Re: Northwest Self Storage

Completeness Response for CUP-16-01 et al. Project Number 2150120.01

## RESPONSE TO PLANNING DEPARTMENT COMMENTS

Exhibit E: Shared Driveway Exhibit

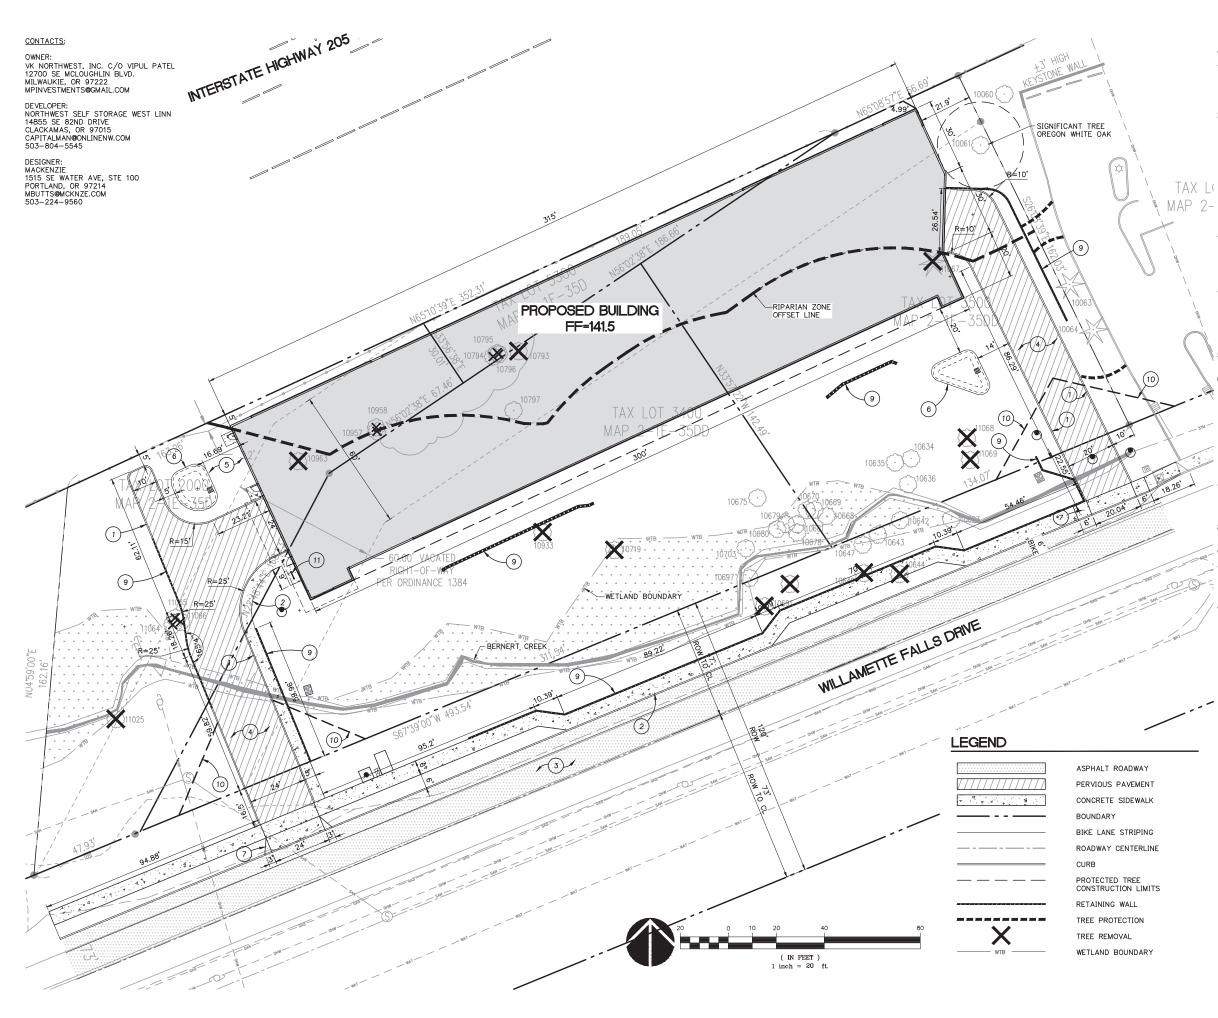
Applicant should provide a shared access easement on the east side of the development for future access consolidation.

**Response:** The Transportation Letter and narrative discusse the possibility of future driveway consolidation with the property to the east. The existing driveway to the east would be the appropriate location for a shared driveway as it is aligned with 6th Street whereas the eastern driveway on our site is proposed offset from 6th Street. Therefore, an access easement on our site is unnecessary and inappropriate. The applicant would not object to a condition requiring this property to allow its eastern driveway to be realigned to form a shared driveway configuration (i.e., with a "Y" north of the Willamette Falls Drive right-of-way) as part of a future redevelopment of the "2500 Building" site, provided that the required permitting and construction would be the responsibility of the redeveloper of that property.

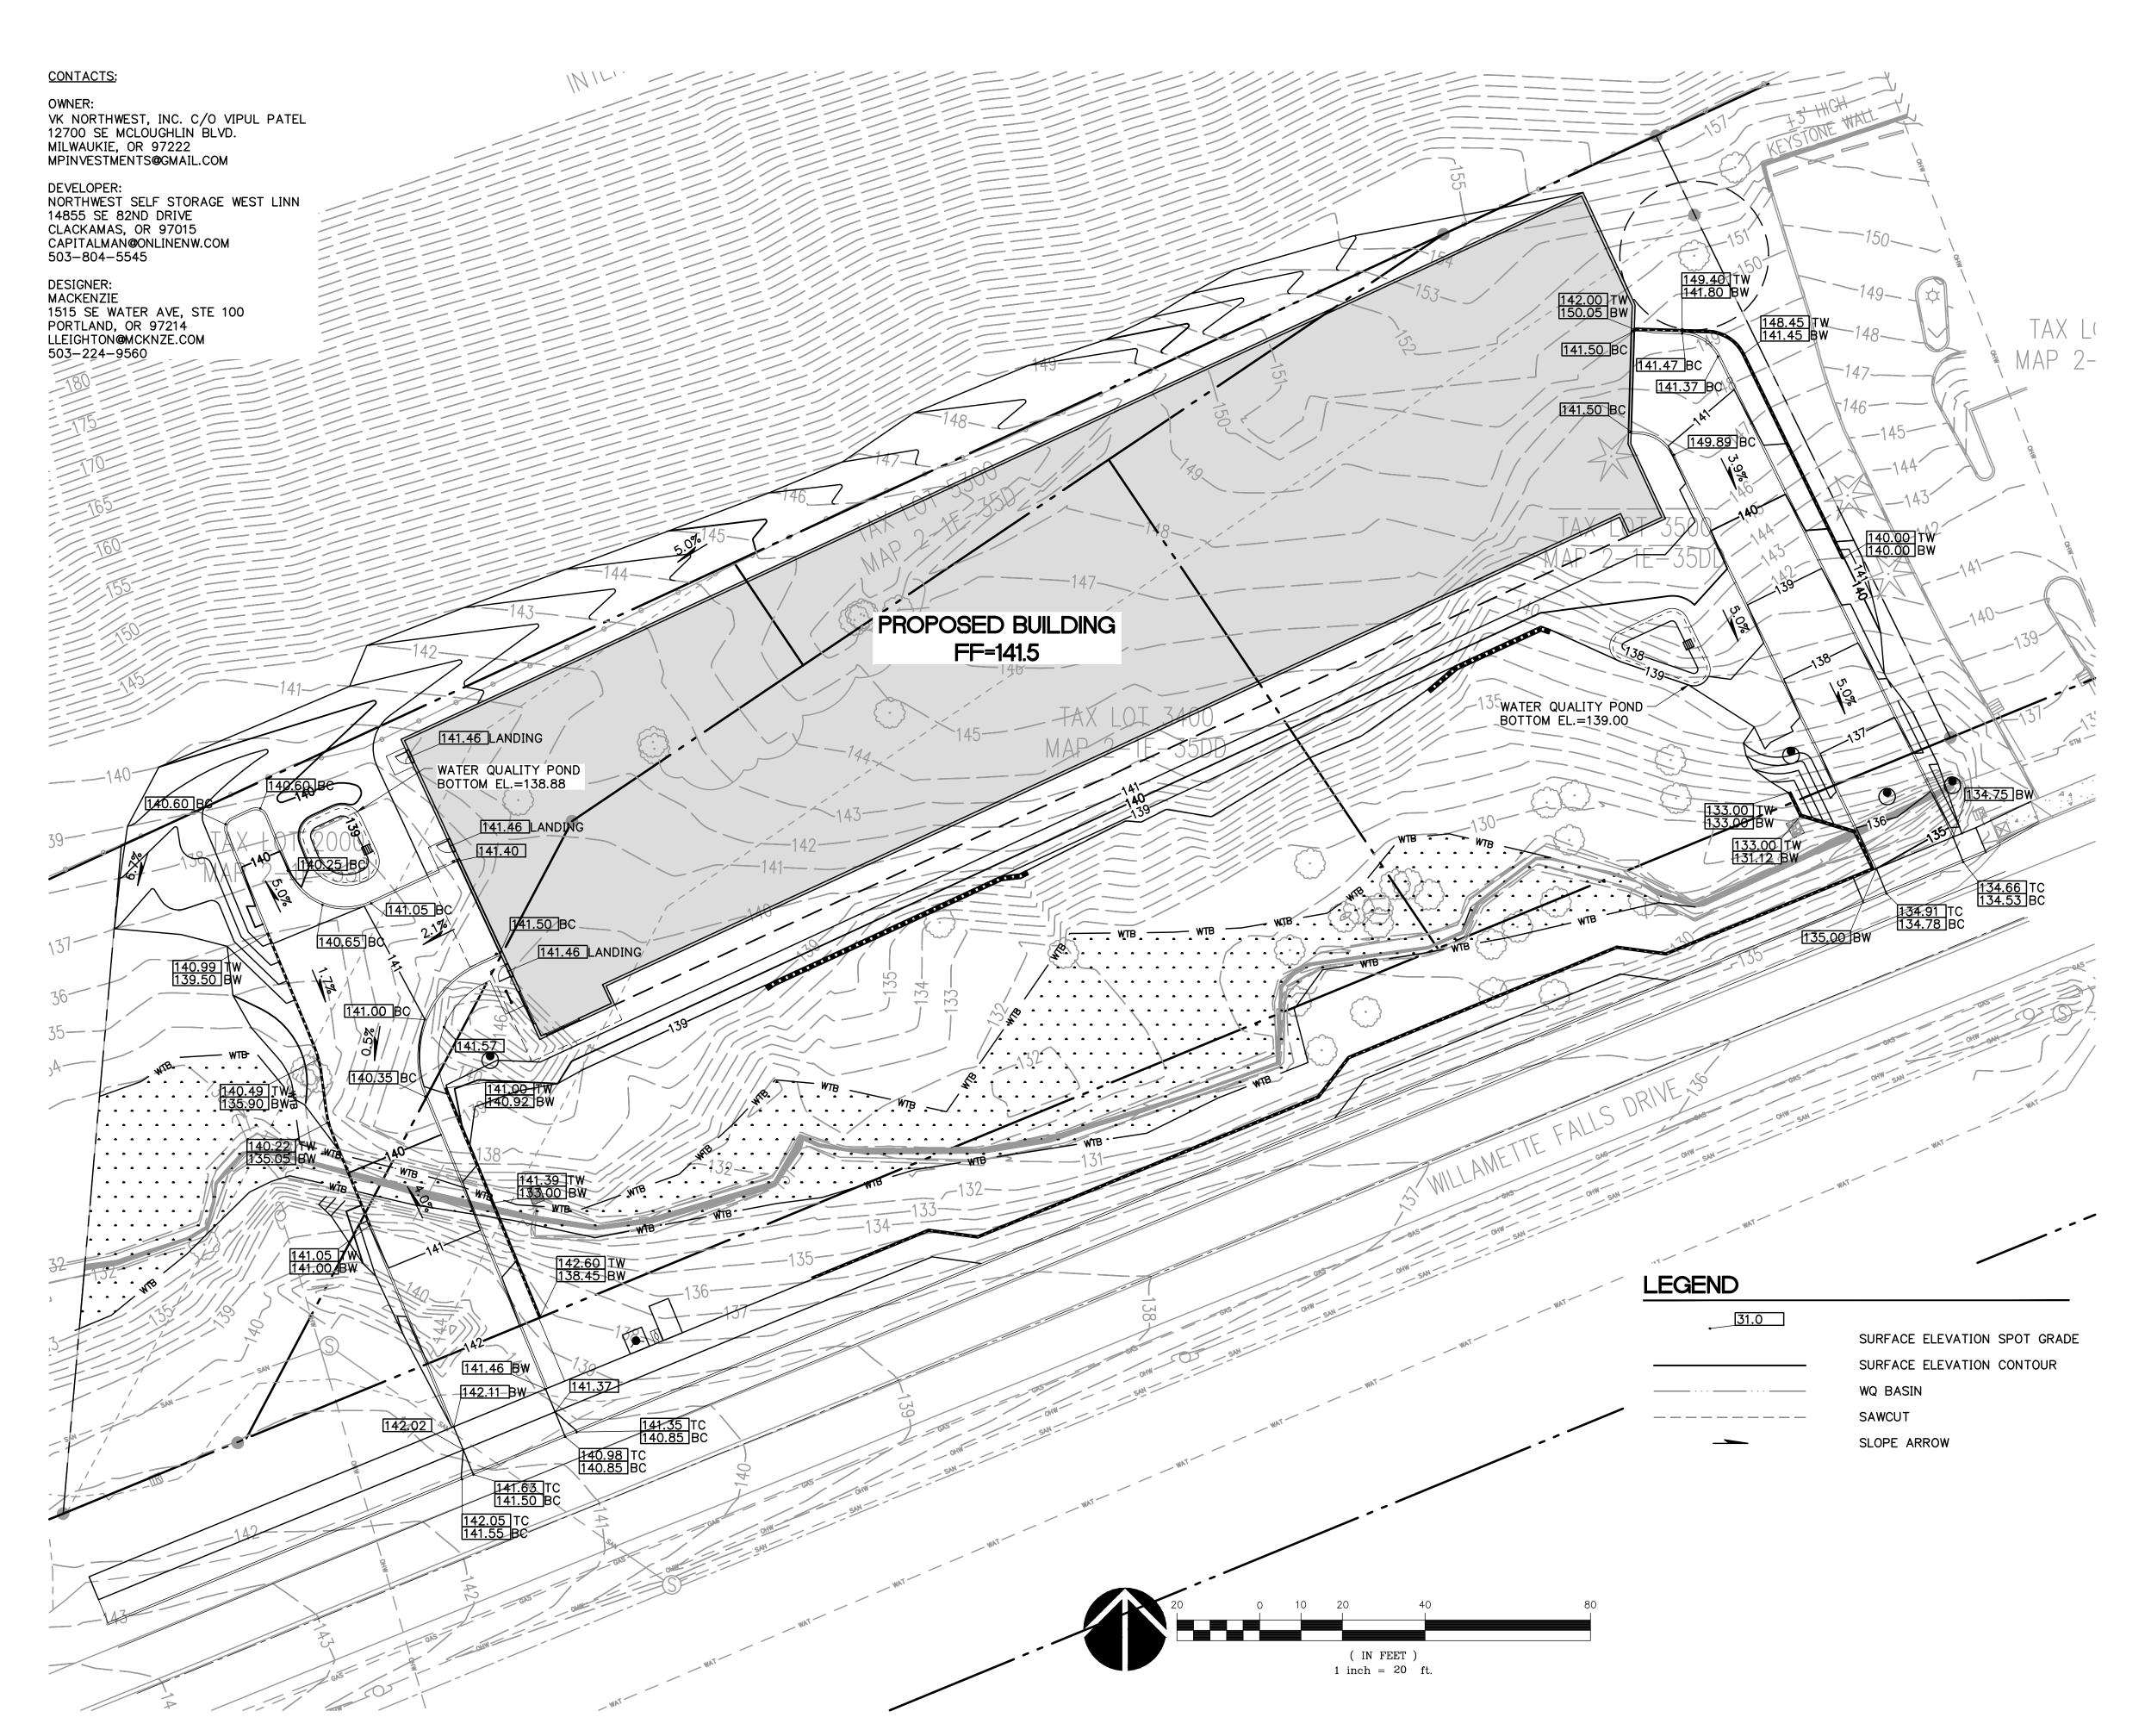
• Even though the Transportation Letter addressed the sight distance criteria, the clear vision area on sheet C2.0 was not shown as depicted in the CDC 42.040.

**Response:** The vision clearance triangles depicted on Sheet C2.0 have been amended to comply with the provisions of CDC Chapter 42. The western driveway, with a width of 24 feet, satisfies CDC 42.040, while the eastern driveway, with a width of 20 feet, satisfies CDC 42.050.
